HISTORIC AND DESIGN REVIEW COMMISSION

March 21, 2018

HDRC CASE NO: 2018-110
ADDRESS: 170 HERMINE BLVD NCB
LEGAL DESCRIPTION: 9007 BLK 13 LOT 5&6
ZONING: R-4 H
CITY COUNCIL DIST.: 1
DISTRICT: Olmos Park Terrace Historic District
APPLICANT: Robert Beldon
OWNER: Joseph Gamez
TYPE OF WORK: Construction of rear addition and deck, window replacement
APPLICATION RECEIVED: March 05, 2018
60-DAY REVIEW: May 04, 2018
REQUEST:

The applicant is requesting a Certificate of Appropriateness for approval to:

ROOF DRAWING

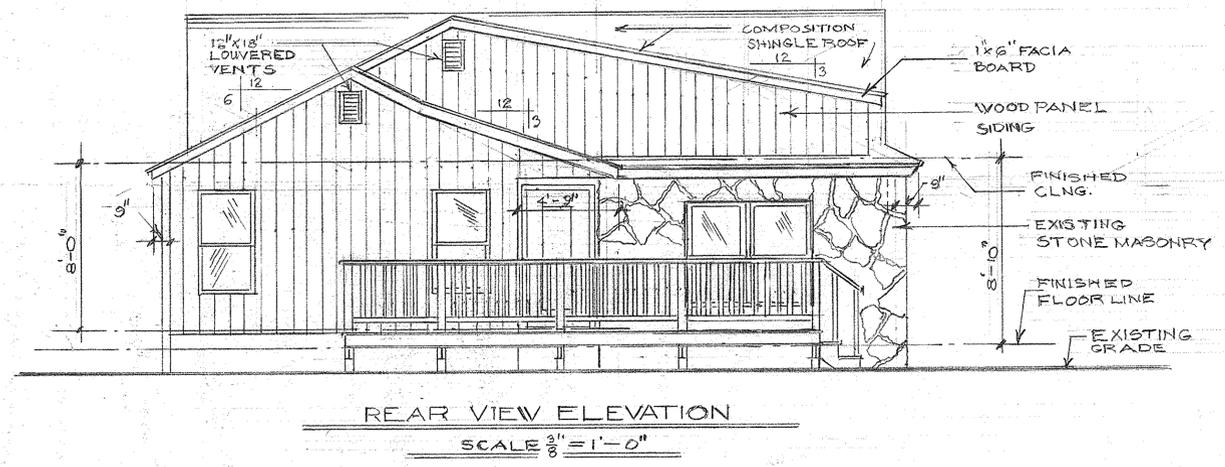
- d. **ROOF ADDITION** – The applicant has also propose to construct a new rear gable roof which would envelope the existing rear hipped roof. The new roof’s ridge would meet at the primary existing gable’s ridge in height. Per the Guidelines for Additions 3.1.B.ii, one should limit rooftop additions to rear facades to preserve the historic scale and form of the building from the street level and minimize visibility from the public right-of-way and full-floor second story additions that obscure the form of the original structure are not appropriate. Staff finds the new taller gable roof would obscure the original hipped roof form with a subordinate height to the primary gable roof.

- reinstall the three removed window openings with wood double-hung windows based on finding B.
2. Staff recommends approval of the rear addition as proposed based on finding C.
 3. Staff does not recommend approval of the rooftop addition as proposed based on finding D. Staff recommends the applicant submit a roof form that does not require the removal or covering of the existing hipped roof and/or feature a height that is subordinate to the primary gable of the historic structure.
 4. Staff recommends the approval to install a rear wood deck as proposed based on finding E.

Line #1	Mark Unit: A	Net Price:		1,419.14
Qty: 2		Ext. Net Price:	USD	2,838.28

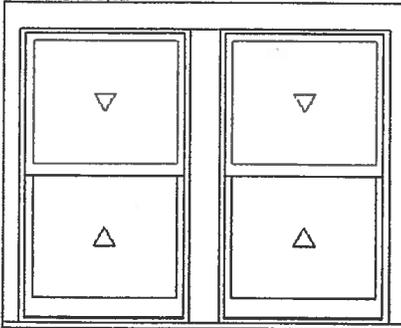
- b. **WINDOWS** – The homeowner had replaced the original wood windows of the home with vinyl windows with wood trim, as well as removed three window openings on the side elevation. After the HDRC hearing on February 7, 2018 in which vinyl replacement of wood windows was denied, the homeowner through the applicant is requesting to install wood double-hung windows in all window openings as well as restore the three removed window opening on the side elevation. Per the Guidelines for Exterior Maintenance and Alterations 2.B. iv. new windows should match the historic or existing windows in terms of size, type, configuration, material, form, appearance, and detail when the original windows are deteriorated beyond repair. The proposed windows feature meeting rails that are no taller than 1.25” and stiles no wider than 2.25”. There should be a minimum of two inches in depth between the front face of the window trim and the front face of the top window sash. This must be accomplished by recessing the window sufficiently within the opening or with the installation of additional window trim to add thickness. Window trim must feature traditional dimensions and an architecturally appropriate sill detail. Window track components must be painted to match the window trim or concealed by a wood window screen set within the opening. Staff finds the proposed wood double-hung windows consistent with the Guidelines.

1. Staff recommends approval to replace the windows with the wood double-hung windows as proposed and to
